Sundry Print Report

Well Name: ANGEL PEAK 24

Type of Action: Plug and Abandonment

CONDITIONS OF APPROVAL

Wellbore Schematic - PROPOSED

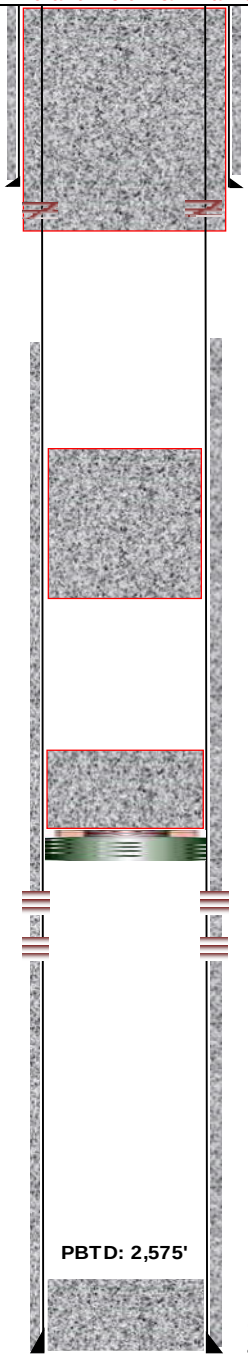
2. The following modifications to your plugging program are to be made:
   a) Add a plug to cover the Pictured Cliffs formation top at 2482'. Or pump a volume of cement below the CICR at 2186' to completely isolate the Fruitland Coal from the Pictured Cliffs.

- No log available for subject well. Operator submitted tops are acceptable based on Reference Well #1.
- Add a plug to cover the Pictured Cliffs formation top at 2482’.
- The plugs proposed in the P&A procedure, with changes recommended above, will adequately protect any freshwater sands in this well bore.
- Fruitland coal perfs 2236’ – 2362’.
